# UNITED STATES PATENT AND TRADEMARK OFFICE

| APPLICATION NO.   | FILING DATE | FIRST NAMED INVENTOR | ATTORNEY DOCKET NO. | CONFIRMATION NO. |
|---|-------------|----------------------|---------------------|------------------|
| 10/722,859  | 11/26/2003  | Robert R. Turvey     | J-3668A             | 8567             |

**Office Action Summary**

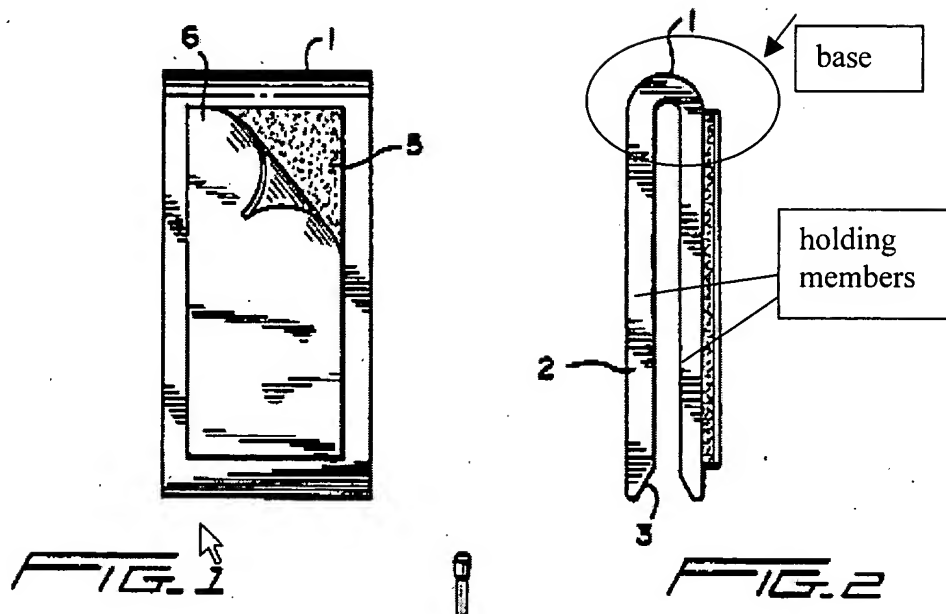
Concerning claims 1, 4, 5, 8, 9, 14, 16, 19, 20, 23, 24 and 32, Raum, Sr. ('721) discloses a holding device capable of moving a slider of a thermoplastic bag in a first direction, comprising: a base surface (see Fig. 2 provided herein), and a pair of holding members (2, see Fig. 2 provided herein) extending from the base surface and capable of being insertable over a slider in a first direction and facilitating movement of the slider in a second direction;

(concerning claims 4 and 19) at least one of the holding members or the base surface includes double-sided adhesive tape (5, 6) on an outer surface thereof;

(concerning claims 9 and 24) a notch (3) in at least one of the holding members aids a user in spreading apart the holding members manually;

Concerning claims 46, 49, 52, 60, Raum, Sr. ('721) a holding device (see Figs. 1 and 2 provided herein) comprising: a base surface; a pair of holding members (extending from the base surface; and means (end structure 3) for inserting the holding members over the slider in a first direction; and wherein the holding members being capable to facilitate movement of the slider in a second direction;
